Tuesday, 12/08/2008 11:26:20 AM User Linda Lacelle **Process Sheet** : CU-DAR001 Dart Helicopters Services Drawing Name HINGE BRACKET Customer : 41166 Job Number : 10345 **Estimate Number** : D28571 Part Number P.O. Number : D2857 REV B **Drawing Number** This Issue : 12/08/2008 : N/A : NC Project Number Prsht Rev. ' **Drawing Revision** : MACHINED PARTS First Issue : .// Type : 38680 **Previous Run** Material Each **Due Date** : 15/09/2008 24 Um: Written By Checked & Approved By 00.06.22 Comment Removed P/O for powder coat EC Est D 06.05.01 Added level 8\_\_ EC **Additional Product** Job Number: Seq. #: Description: 6061-T6 Bar 2.00 x 1.25 1.0 M6061T6B2000X01250 not enough mat of this batch in computer 0.4594 f(s)/Unit Total: 11.0250 f(s) Comment: Qty.: Material: 2.00" X 1.25" but had enough in the rack of 6061-T6 (QQ-A-225/8 or QQ-A-250/11 or QQ-A-200/8) batch # (M6061T6B200001250) Batch M 105838 BAND SAW BAND SAW 2.0 Comment: BAND SAW Cut blanks 5.2" HAAS1 HAAS CNC VERTICAL MACHINING #1 Comment: HAAS CNC VERTICAL MACHINING #1 1-Machine per folio D2857-1 2-Deburr any rough edges QC2 INSPECT PARTS AS THEY COME OFF MACHINE 4.0

DART AEROSPACE LTD	Work Order:	41160
Description: Hing

D2857-1 HINGE BRACKET D2857-2 OPPOSITE

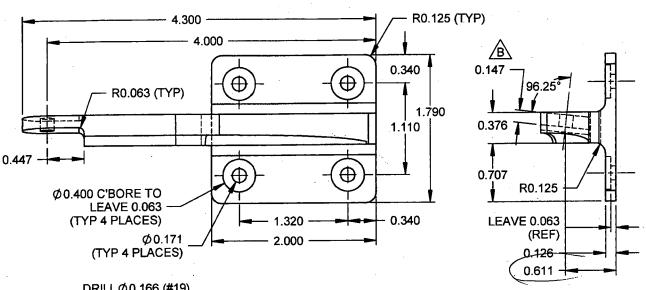
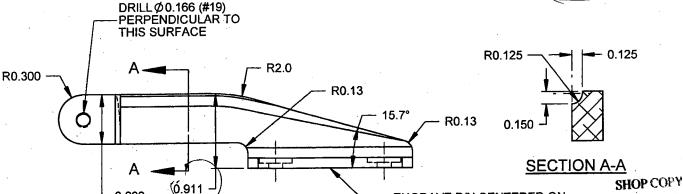
NCR: 4	1166	W	WORK ORDER NON-CONFORMANCE (NCR)									
DATE	STEP	Description of NC Section A	Initial Chief Eng	Corrective Action Section B  Action Description Chief Eng	Sign & Date	Verification Section C	Approval Chief Eng	Approval QC Inspector				
08/08/28	30	origin on the Yaxis was off by .010" so witible Demension was oft. dias of .166 was too big. R.C. operator even and choose wrong drill.	neder (	PAX	25 08/08/2V	ododor		Colorb				
ÚÉ.82.22	3	Dim 0.911 & 0.611 was is UNDER TUL By 0.004	08108-29 PC 051047			order	08.08.25 po 05.125	es or or

Qty(1) D2857-1 Hinge Bracket, the height of the arm is shifted down 0.014" (0.004" below tol). The width of the arm is to dwg so the part is the same strength. I don't think this will cause a fit problem, I think its acceptable. It's a non-landing gear part (QSI 042), what do you think?

If you are convinced that the part will fit OK, then go ahead and accept the part on my behalf. I don't see a structural problem.
